AR-3 Crossover Schematics

During its production cycle, AR modified the AR-3 crossover schematic several times. This note attempts to catalog those changes based on detailed information available in Tom Tyson's files. At some point a complete description of the AR-3 will be written [TT]; at that time this should become an appendix within that document.

A. Initial production through serial number C1413:

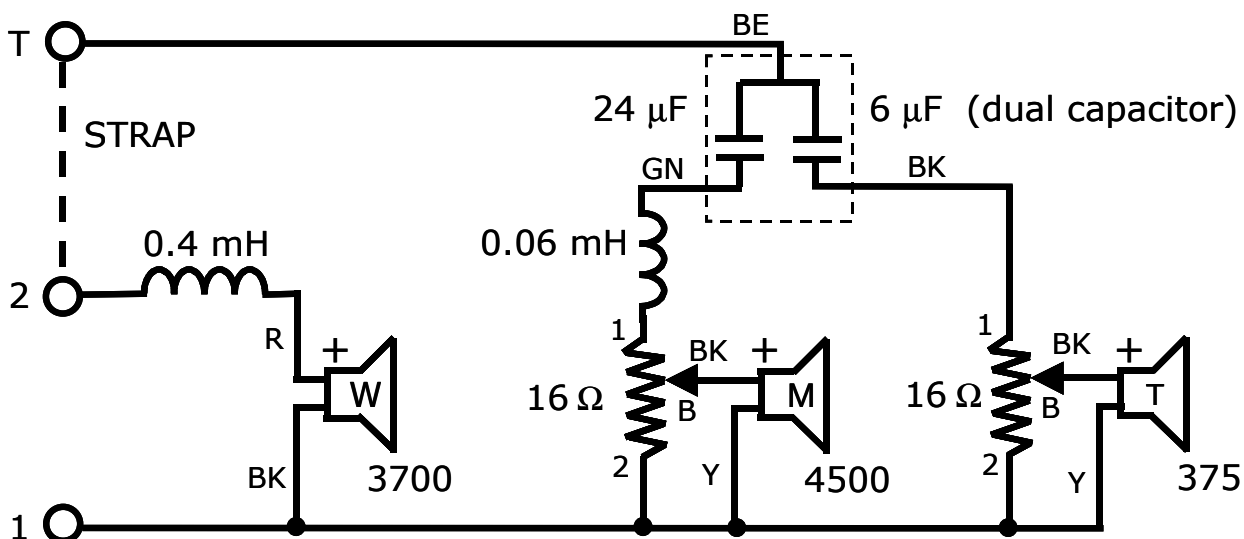
The schematic shown here; dated 13 March 1959 and initialed by EMV, is the original AR-3.

B. Serial numbers C1414 – C19467:

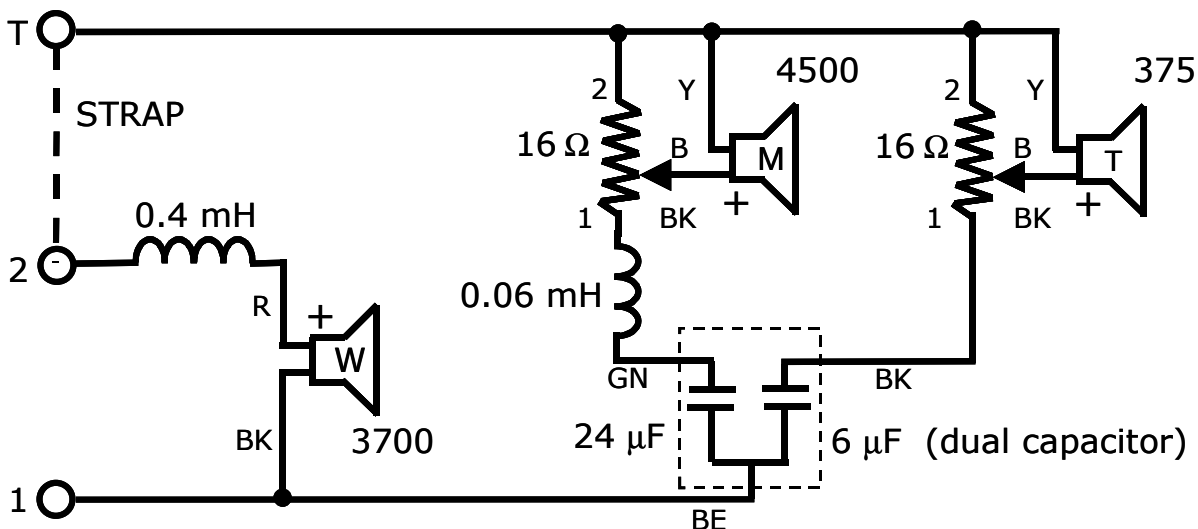
In 1960 the crossover was changed to reverse the phase of the mid-range and tweeter with respect to the woofer [1]. This was the only change made at this point in production.

C. Serial numbers C19468 – C70228:

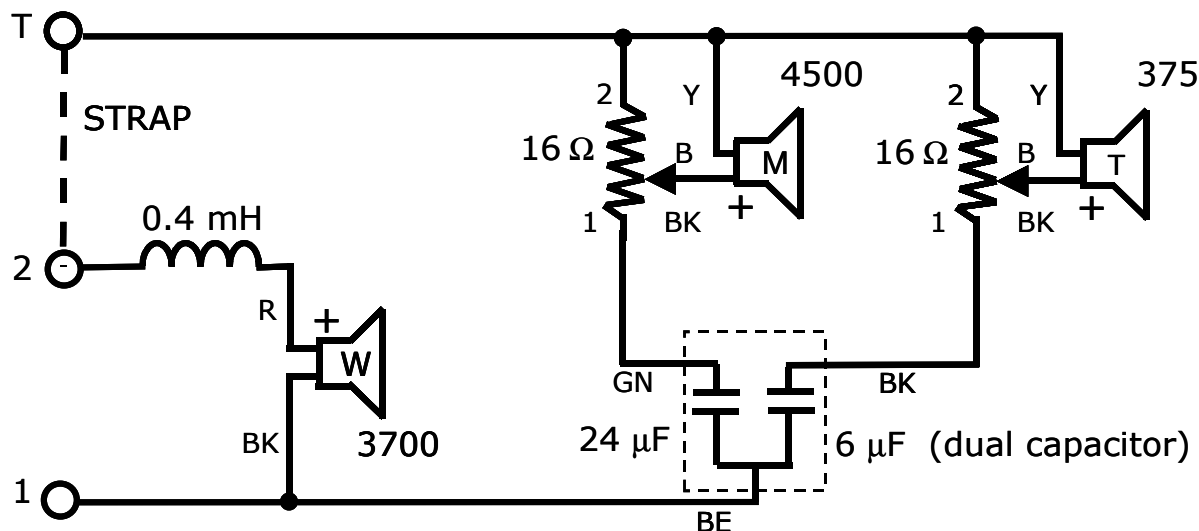
The crossover was modified on 25 Aug. 1965 by removing the 0.06-mH (51-turn) coil in the mid-range crossover.

D. Serial numbers C70229 to end of production:

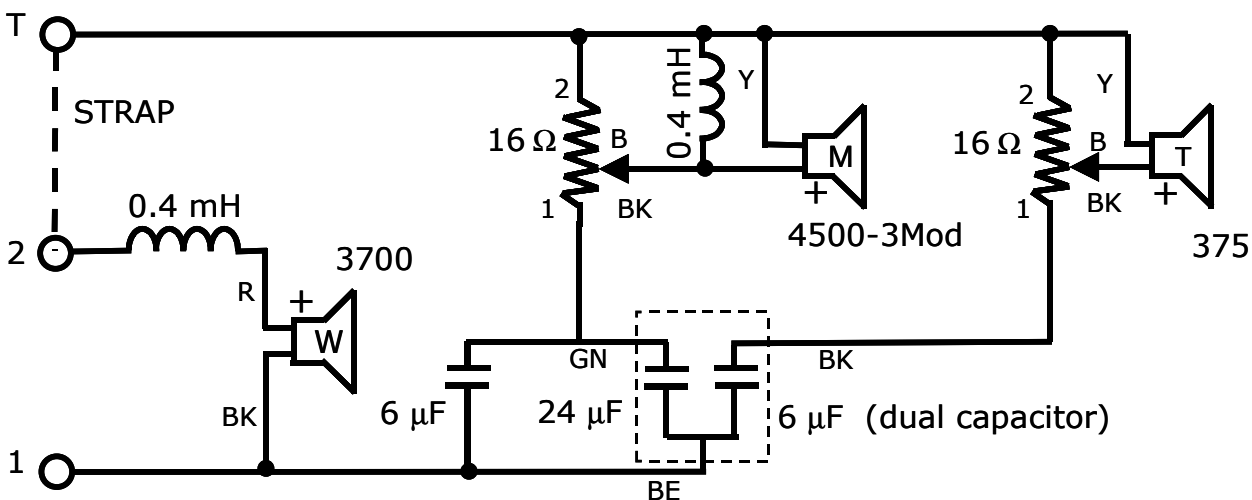
On 13 May 1970, AR ran out of the original phenolic-dome mid-range. This required the use of a version of the AR-3a mid-range identified by part number 4500-3MOD and later identified as part number 200010-AR-3 or 200019-3. (These are Fig's. A.9 and A.10, respectively, in *Restoring the AR-3a*.) This required a crossover change, as the AR-3 and AR-3a did not have the same woofer-mid-range crossover frequency. This crossover change consisted of the addition of a 6-μF capacitor in parallel with the 24-μF (to make a total of 30 μF) and the addition of a 0.4-mH (143-turn) coil across the mid-range driver. These changes are illustrated below.

E. Replacing the AR-3 mid-range with a service replacement:

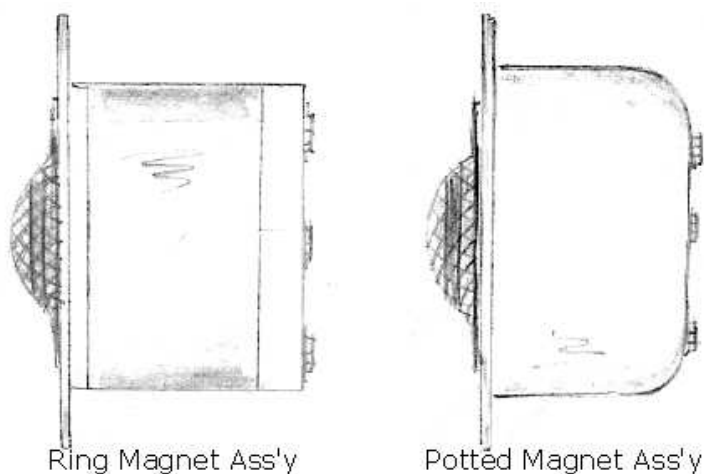
After the original mid-range supplies were exhausted, the new driver described in Section D was used for both production and service replacement. *So it is possible that an Internet-purchased speaker contains a service replacement mid-range.* Service replacement was not straightforward, as the crossover had to be changed to that shown in Section D. Thus, speakers with serial numbers of C19467 and lower needed to have their 51-turn coil removed before the parts for the new service replacement were added. Speakers with serial numbers greater than C70228 would not have needed the crossover modification, since the new style mid-range was installed when originally assembled.
